STRUCTURAL ADDENDUM-No: SA-01

Re: 321 John Street, Cobourg, ON
Clarifications & Updates to Structural Documents

The following items are changes to project Contract Structural Documents. General Contractors shall include the items described in their tender bid including all labour, material, equipment and services required to complete the work described.

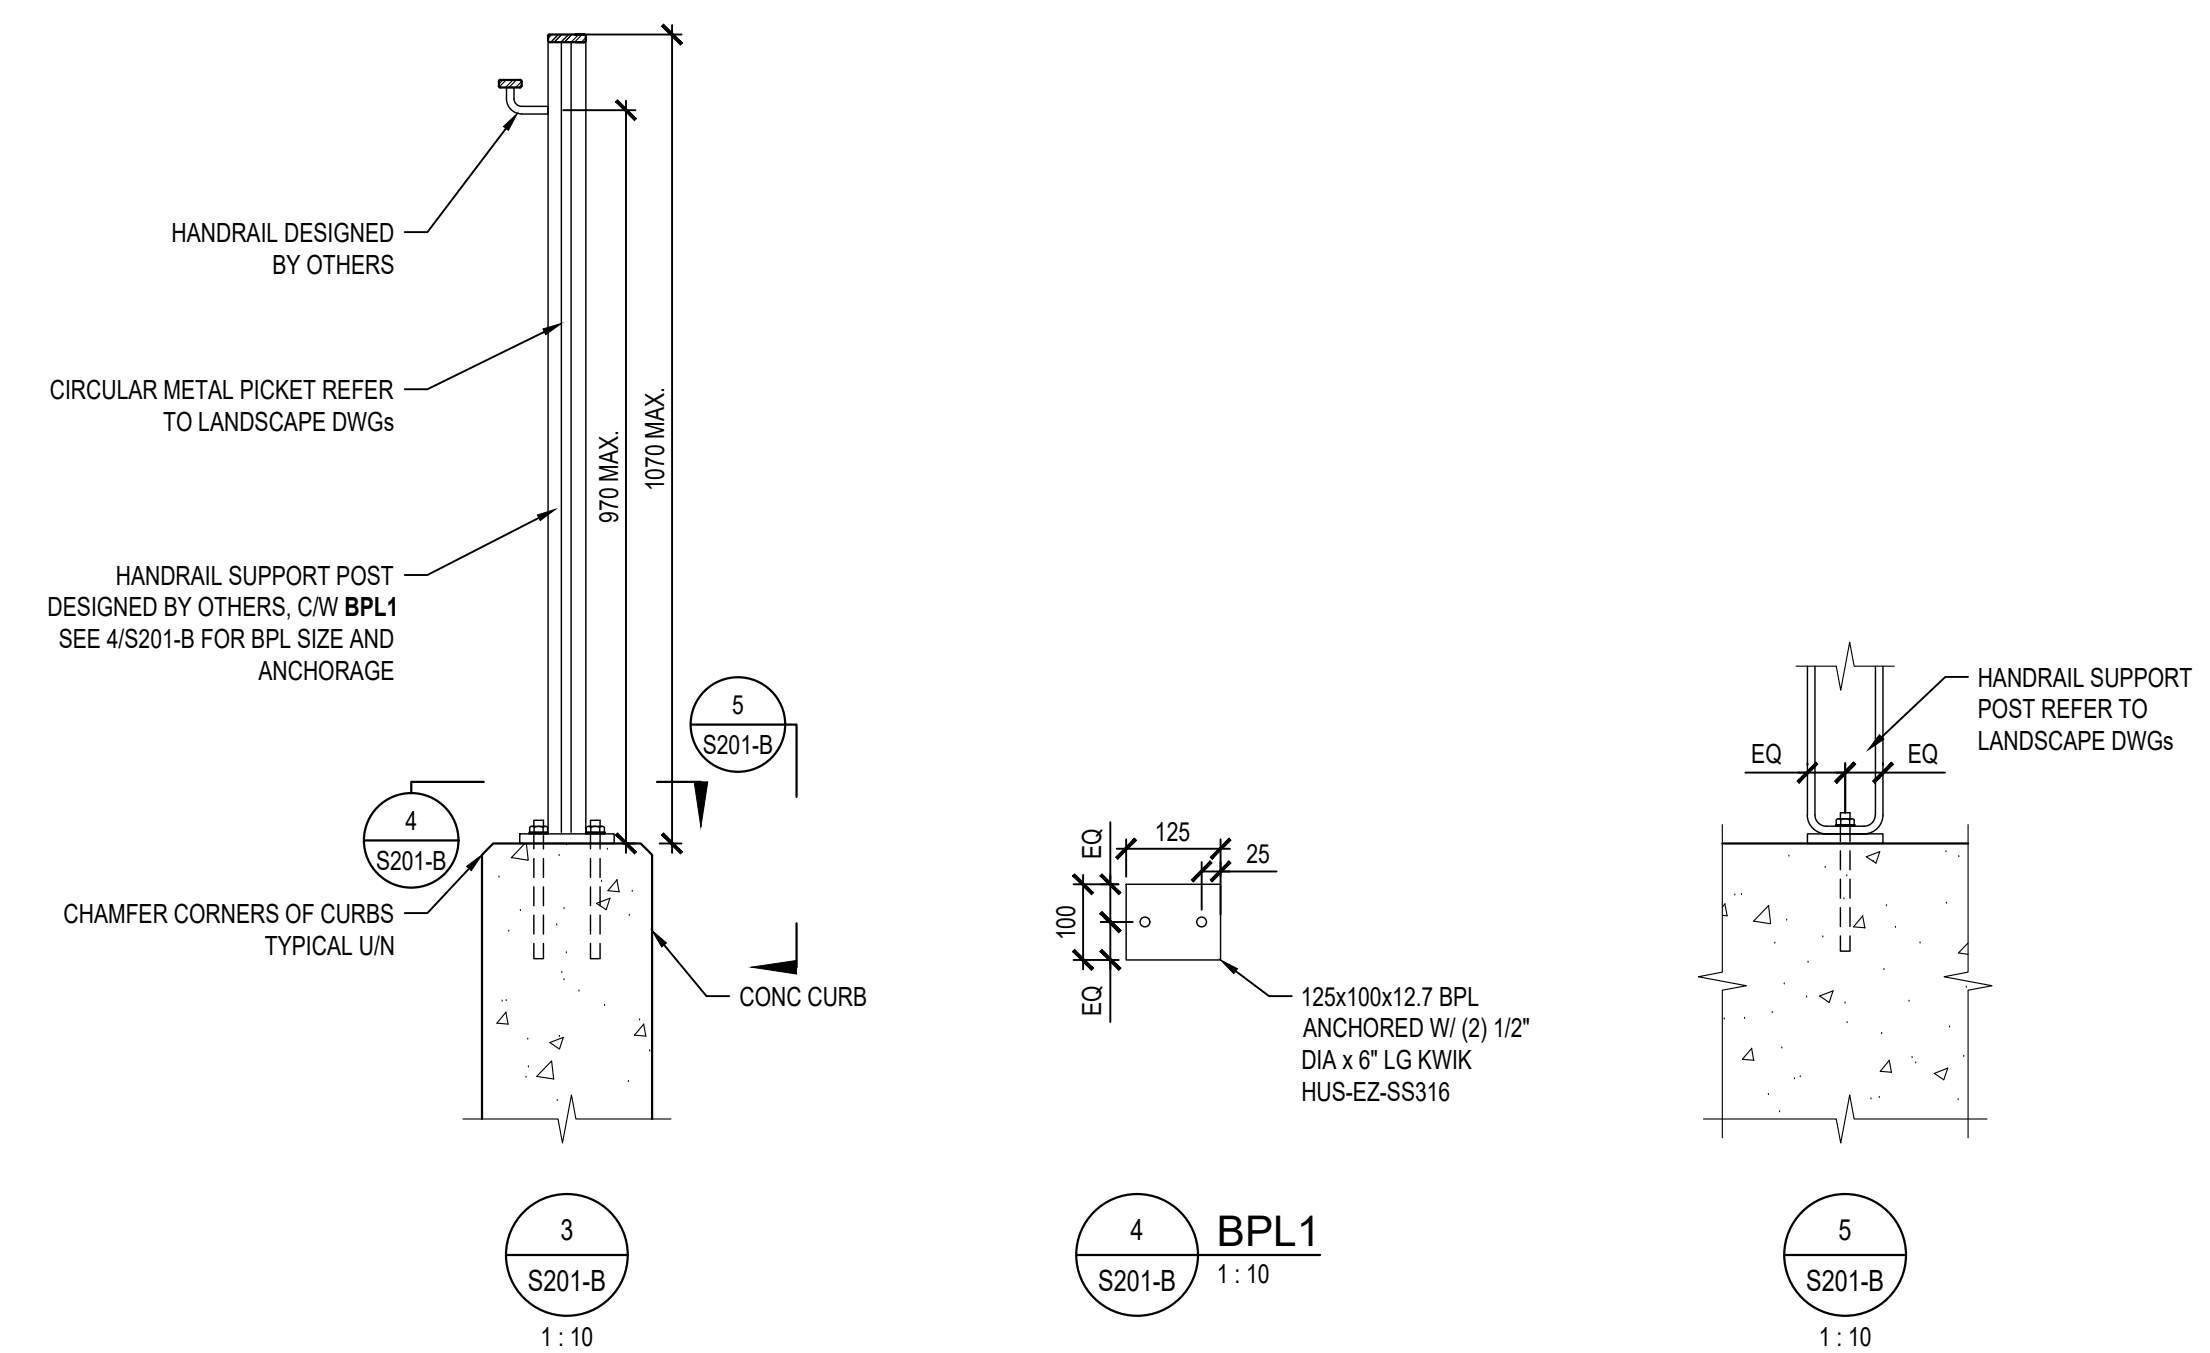
Description of Drawings Revised & Revisions**1.0 S201 Foundation Plan**

- 1.1 Clarity added to between sleeving through foundation wall and under footing. Additional sleeves under footings added.
- 1.2 Two slab depressions removed. One slab depression added in mechanical room.

S202

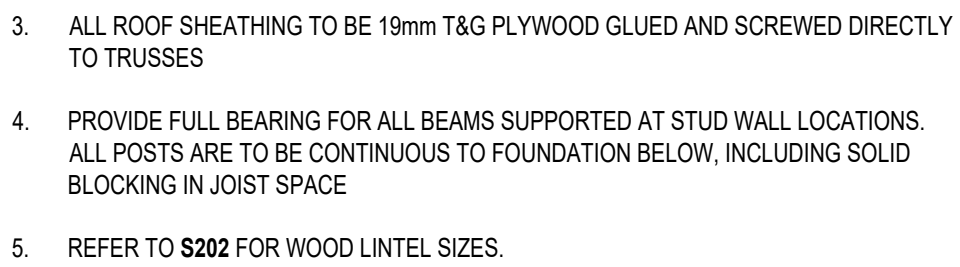
3.0 S202 Main Floor Showing Second Floor Framing Plan

- 3.1 Stair landings reconfigured, beam added to one landing on each stairwell to support stringers above.
- 3.2 Mechanical chase sizes increased based on architectural request. LVL reinforcement added around opening.
- 3.3 Reinforcement for water heaters adjusted.
- 3.4 Extent of exterior walls adjusted in four locations.
- 3.5 Clarity added for suspended mechanical units below wood I-joists.
- 3.6 Four lintel sizes adjusted.

S204

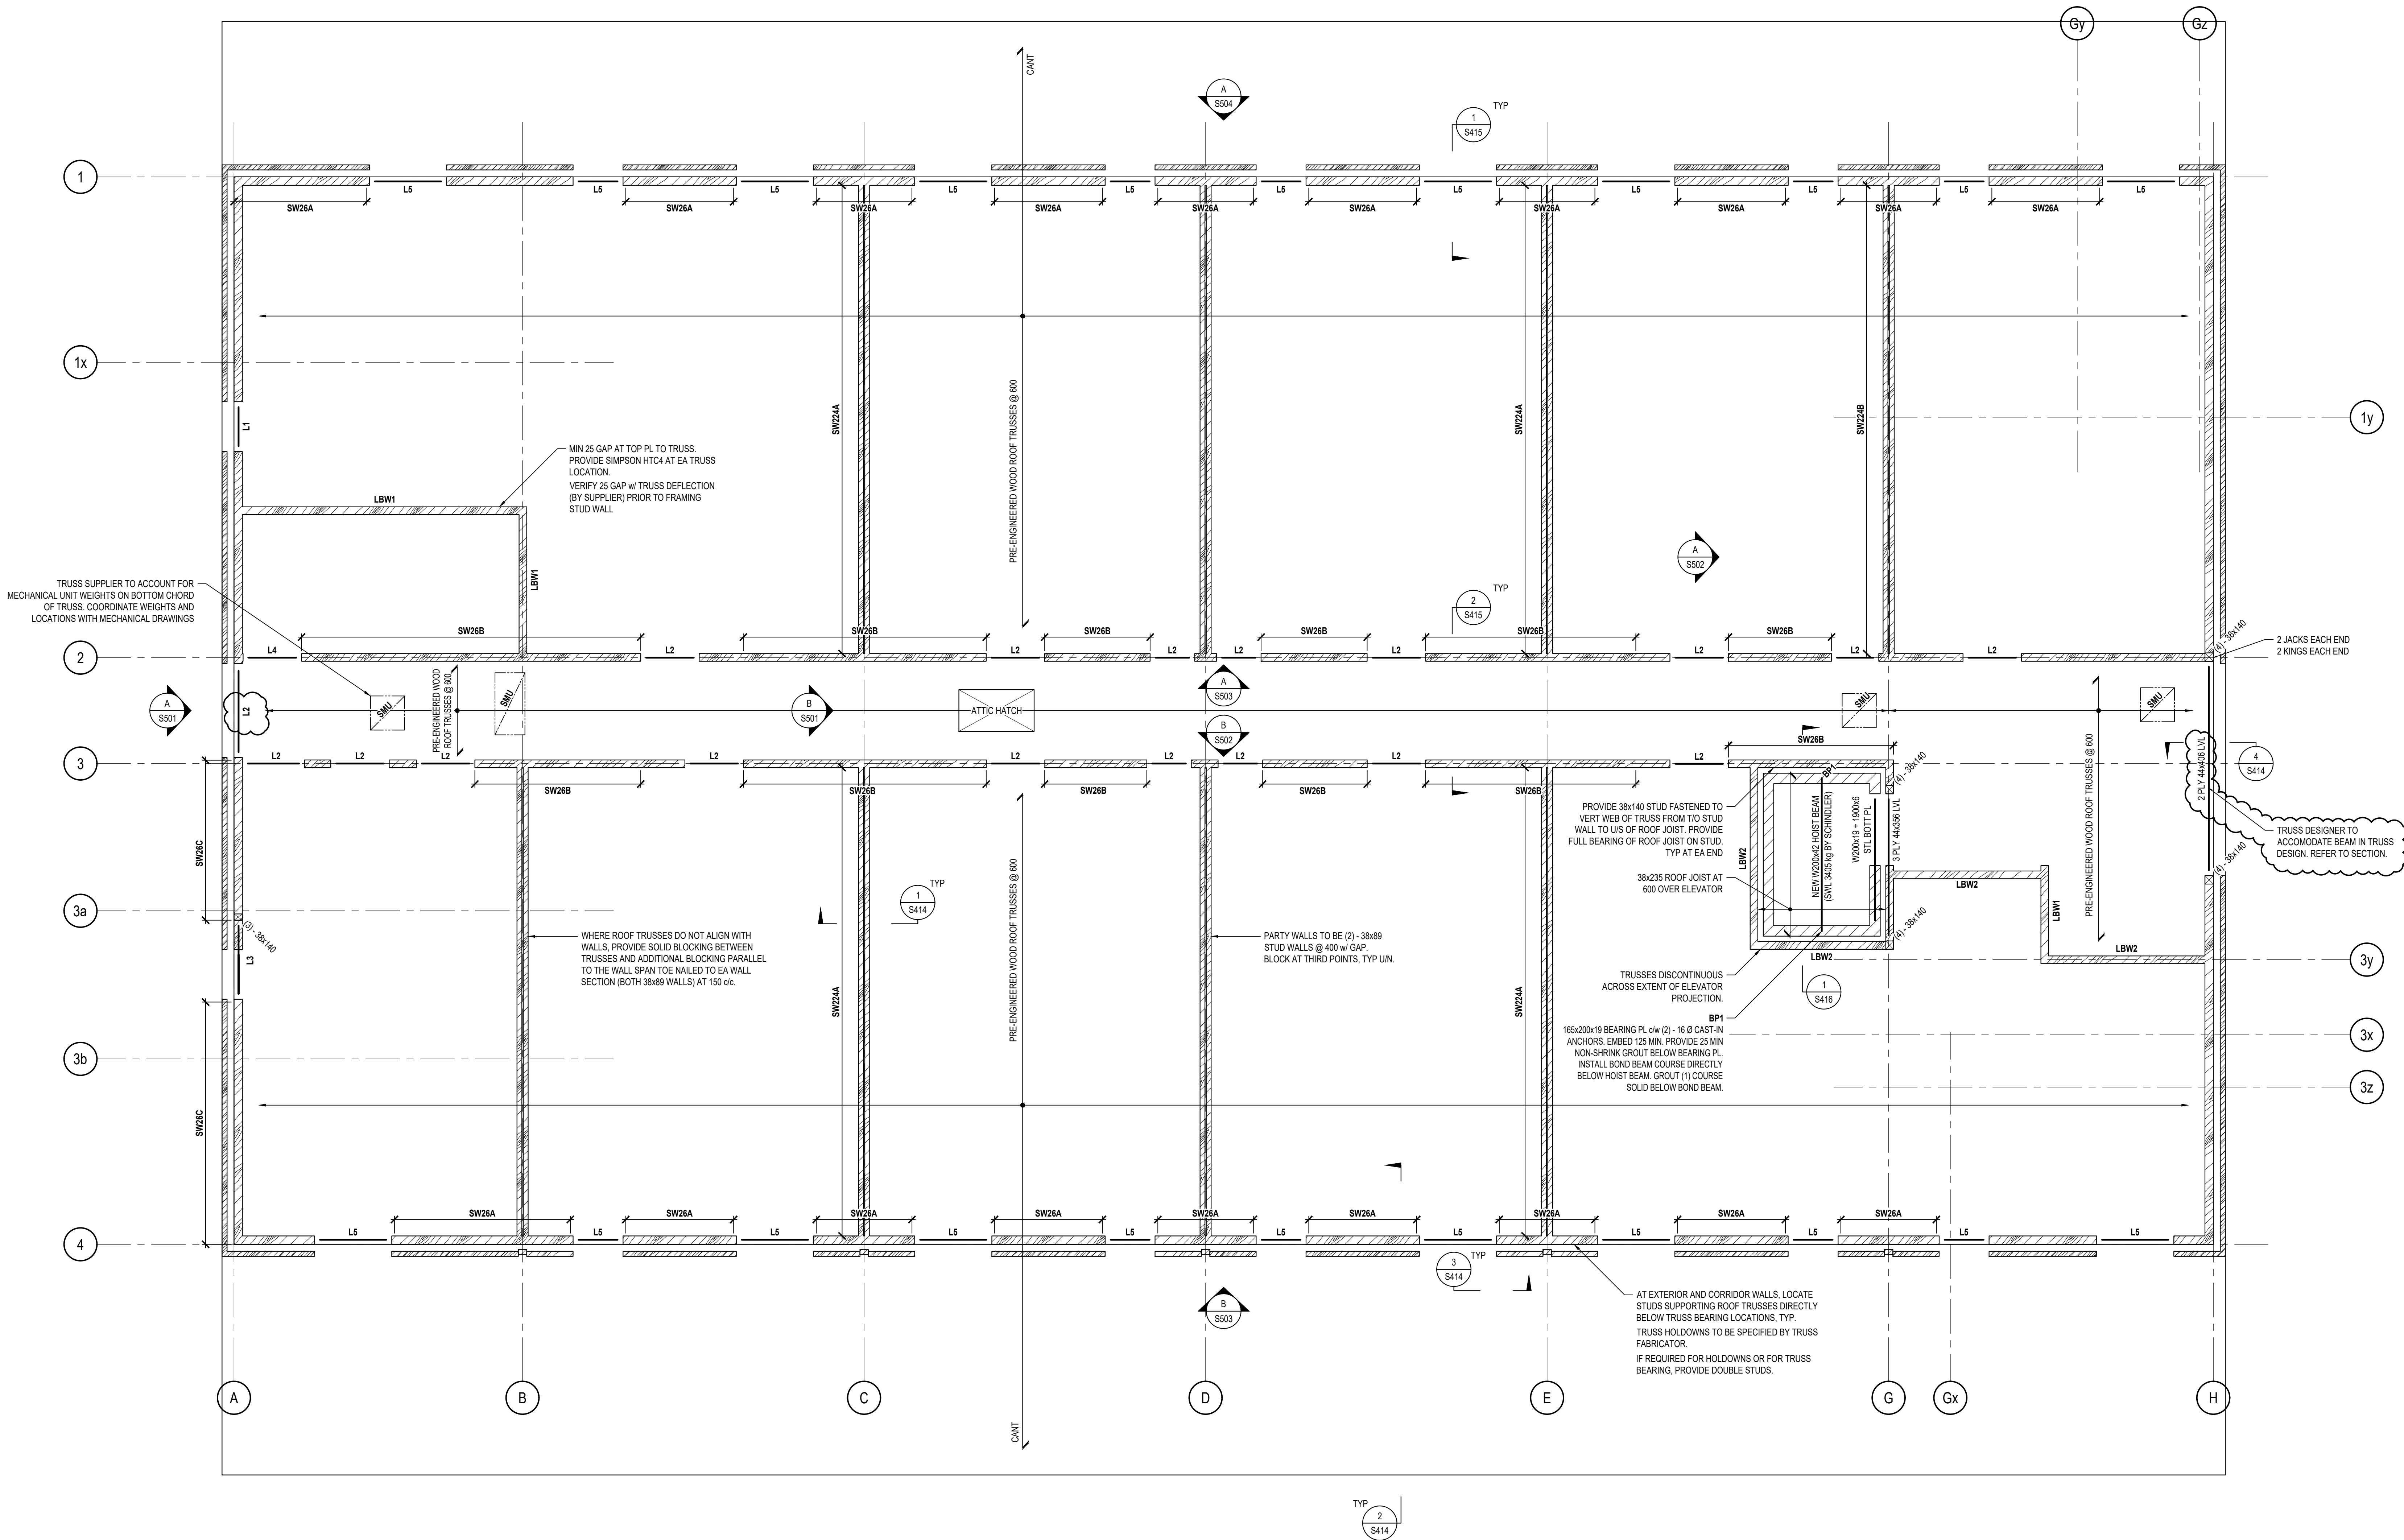
5.0 S204 Third Floor Showing Roof Framing Plan

5.1 Two lintel sizes adjusted.

S411

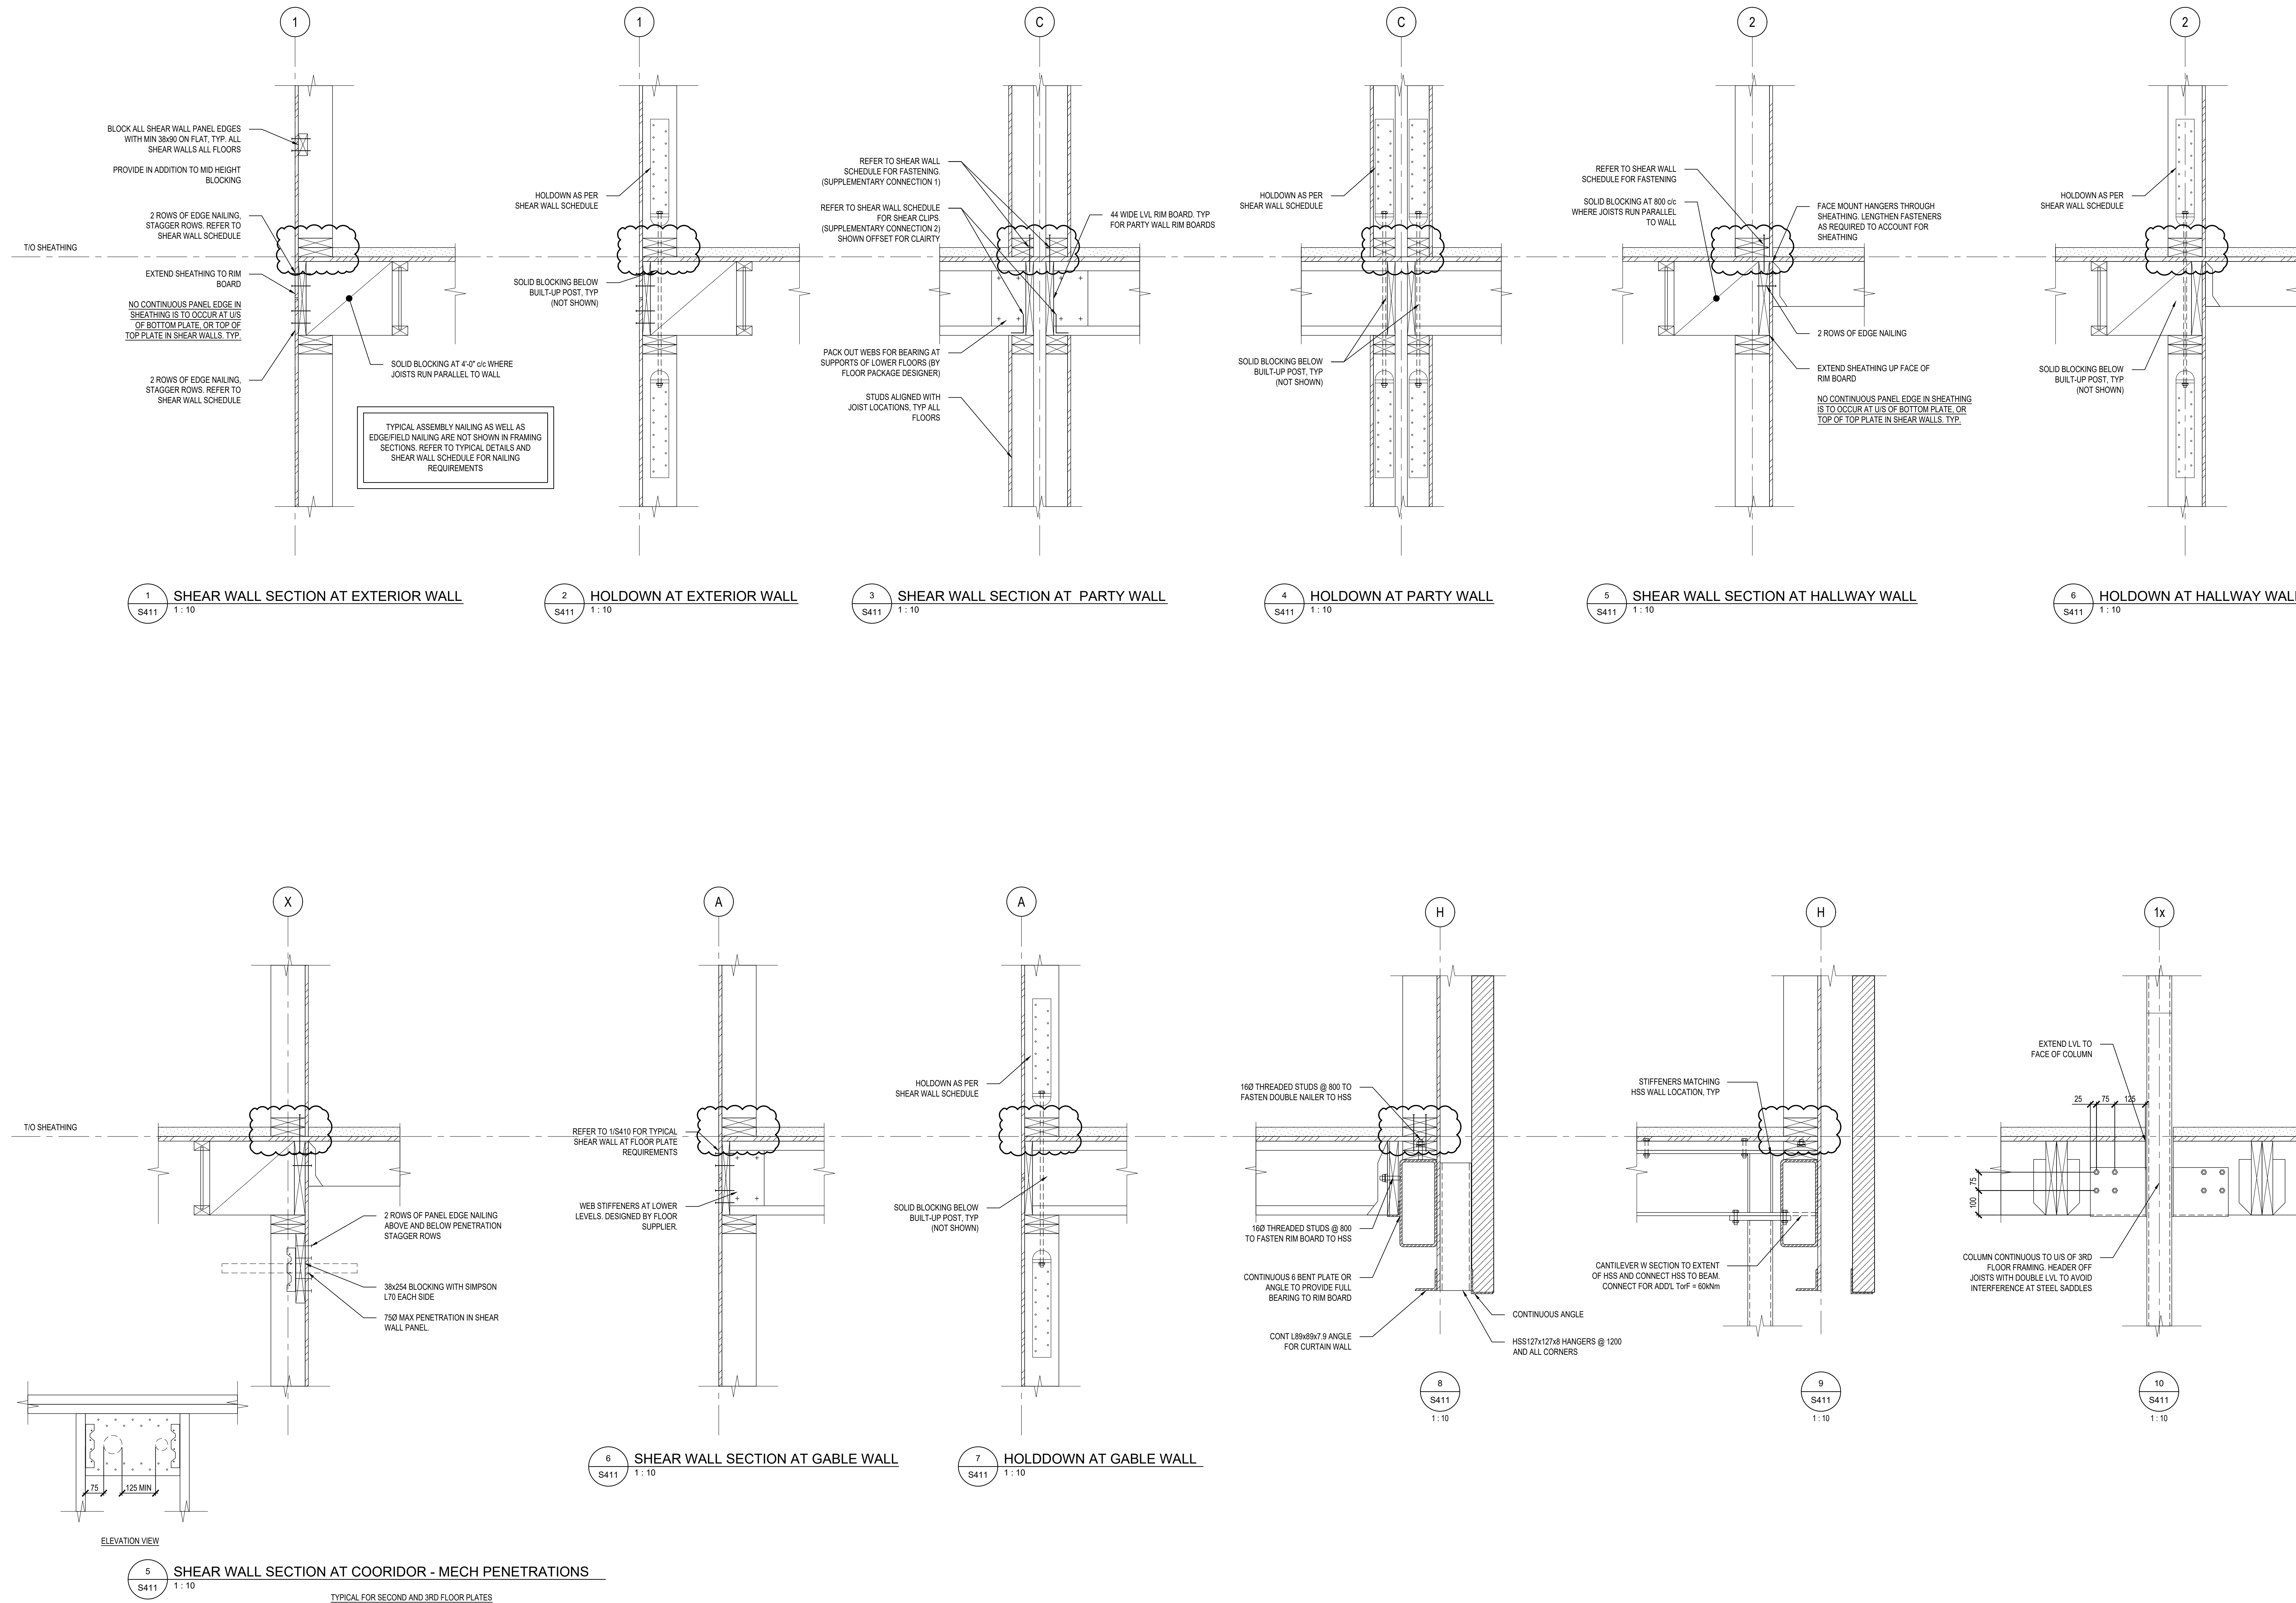
8.0 S411 Sections and Details

8.1 Sections adjusted to show double bottom plate.
